Item Name: AH-1F/P/S Replacement Skidtube with Standard Wearplates, Fits LH or RH

DRAWING NO. D2906	TITLE AH-1 (209) SKIDTUBE ASSEMBLY	REV. B	DART AEROSPACE LTD ENGINEERING ORDER		D.E.O. NO. D2906-B-1	SHEET NO. SHEET 1 OF 1	SCALE NTS
DRAWN A.P.	CHECKED <i>[Signature]</i>	MFG. APPR. <i>[Signature]</i>	APPROVED <i>[Signature]</i>		DE APPR. <i>[Signature]</i>		
DATE 12.05.28	DATE 12.05.28	DATE 12.05.31	DATE 12.05.31		DATE 12.05.31

CHANGE ALL C'BORED WELDED CROSSBOLT SPACERS TO SWAGED SPACERS

SECTION C-C A2-2
NOT TO SCALE A2-3

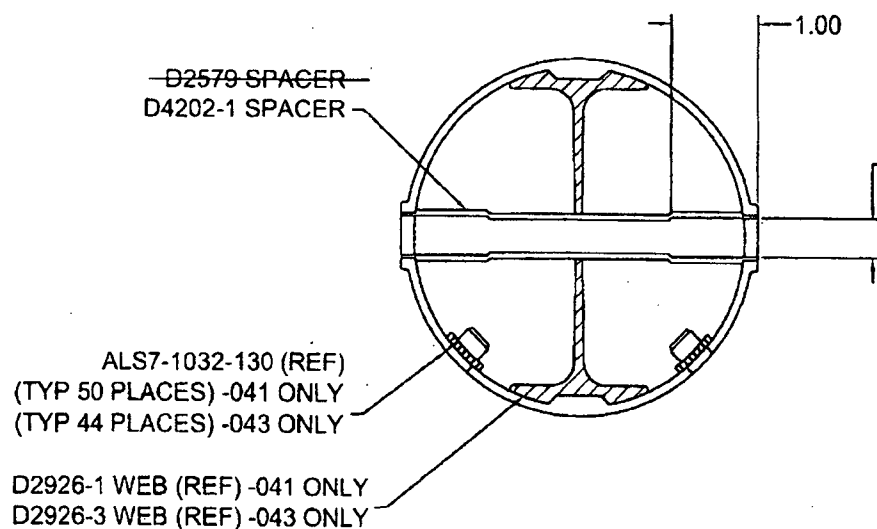
SECTION C-C ON SHEETS 2 & 3 ARE AMENDED AS FOLLOWS FOR ALL HOLES THAT WERE ORIGINALLY C'BORED:

AFTER DRILLING AND BENDING ASSEMBLY
PERFORM THE FOLLOWING FOR Ø0.508 HOLES ONLY:

1. CHAMFER HOLE 0.050 X 45°
2. INSERT D2579 SPACER (20 PLACES)
3. WELD INTO PLACE AND GRIND FLUSH
4. C'BORE D2579 SPACER TO Ø0.437 X 1.00 DEEP

1. INSERT D4202-1 SPACER, 22 PL (-041) OR 19 PL (-043)
2. SWAGE TO Ø0.437 X 1.00 DEEP PER QSI 002
3. TRIM / GRIND FLUSH PER QSI 002
